Access Compliance Report

Public Rights-of-Way

Intersection ID: 16141	Main Street: WENDOVER_RD	Cross Street: LATROBE_DR	Location: S
ADA ID: 64B333E006F4	Ramp Type: Perp	Initial Pass/Fail: Fail	Overall Compliance: No
Severity Score: 25			
Codes/Mitigation Info/Possible Solution		Field Measurements/Component Compliance

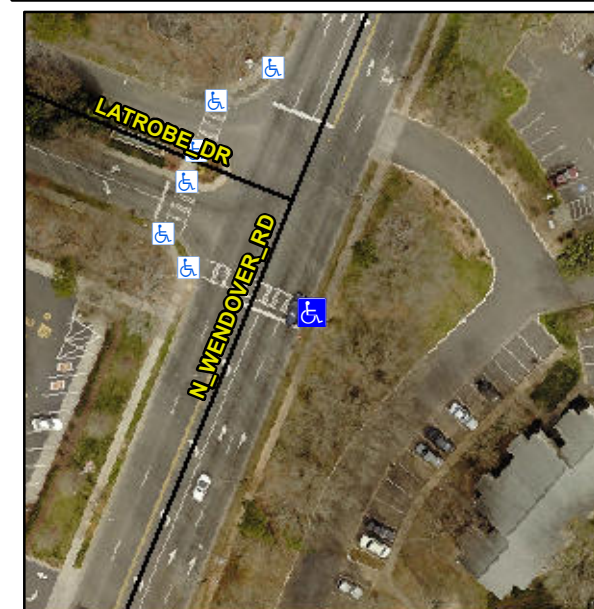
Not Found, R304.2.2

Compliance	Description	Data	Compliance	Description	Data
N/A	Ramp Length (in)	53.0	No	Ramp Slope (%)	16.8
Yes	Ramp Width (in)	48.0	Yes	Ramp XSlope (%)	1.6
N/A	Flare Type LT	N/A	N/A	Flare Type RT	N/A
N/A	Flare Slope LT (%)	N/A	N/A	Flare Slope RT (%)	N/A
N/A	Flare Traversable LT?	N/A	N/A	Flare Traversable RT?	N/A
N/A	Landing Length (in)	N/A	N/A	DWS Provided?	N/A
N/A	Landing Width (in)	N/A	N/A	DWS Contrast?	N/A
N/A	Landing Slope (%)	N/A	N/A	DWS Length (in)	N/A
N/A	Landing X Slope (%)	N/A	N/A	DWS Full Width?	N/A
N/A	Landing Curb? (Y/N)	N/A	N/A	DWS Offset (in)	N/A
N/A	Shared Landing?	N/A			
N/A	Gutter Ponding?	N/A	N/A	Gutter Slope (%)	N/A
N/A	Gutter Lip Ht (in)	N/A	N/A	Gutter X Slope (%)	N/A
N/A	Painted X Walk1?	Yes	N/A	Painted X Walk2?	N/A
	X Walk 1 Direction	To NW		X Walk 2 Direction	N/A
N/A	X Walk 1 Width (in)	104.0	N/A	X Walk 2 Width (in)	N/A
	X Walk 1 Slope (%)	2.9		X Walk 2 Slope (%)	N/A
	X Walk 1 X Slope (%)	1.1		X Walk 2 X Slope (%)	N/A

Remove & Replace Entire Ramp.
